APPROACH AND METHODOLOGY FOR ASSESSMENT OF THE LUANG PRABANG HYDROPOWER PROJECT – HYDROLOGY AND HYDRAULICS, AND SEDIMENT AND RIVER MORPHOLOGY

THE FIRST REGIONAL INFORMATION SHARING ON LUANG PRABANG HYDROPOWER PROJECT
06 NOVEMBER 2019, VIENTIANE, LAO PDR

Dr. Nguyen Duc Tuan, Technical Support Division, MRC Secretariat

Preliminary Findings – Design Flood Analysis

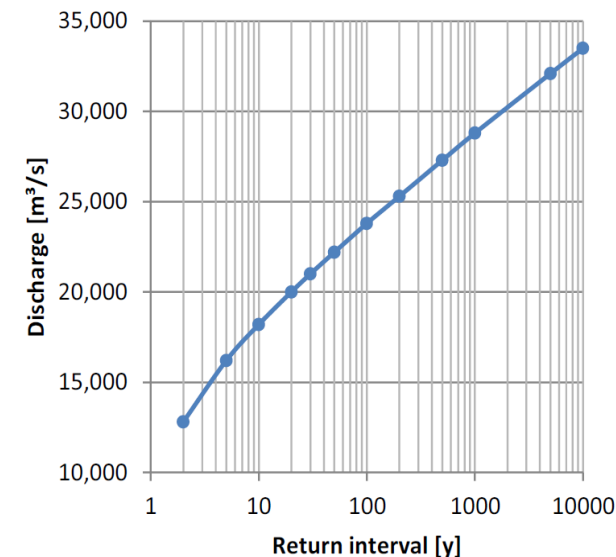
The initial findings are:

- *The design floods estimated at LP HPP should be cross-checked with those at the upstream Pak Beng HPP and the downstream Xayaburi HPP.*
- *The differences among the design floods of three dams should be verified from the expected runoff from the incremental catchment.*

Low Level Outlet Design

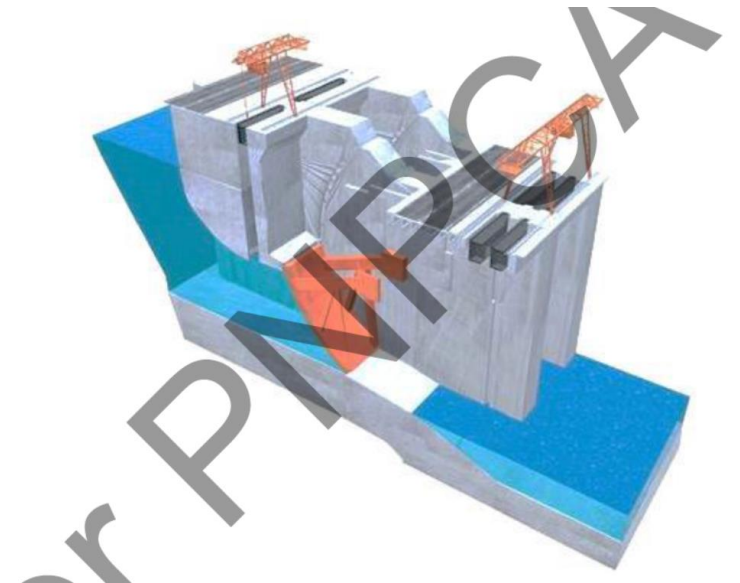
- The Feasibility Study addressed the key points in sediment management and river morphology from the PDG2019 (Chapter 3 – DG);
- There are three (3) low level outlets of 12 m x 16 m and a sill level of 275.0m for sediment flushing and designed for a full supply level of 312.00 msl and flow rate of 3,530 m³/s for each outlet;
- The detailed operation of the dam has not been presented and there is no evident plan for sediment management;
- No quantification of the sediment flushing through low level outlets and operating water levels was not presented as well.
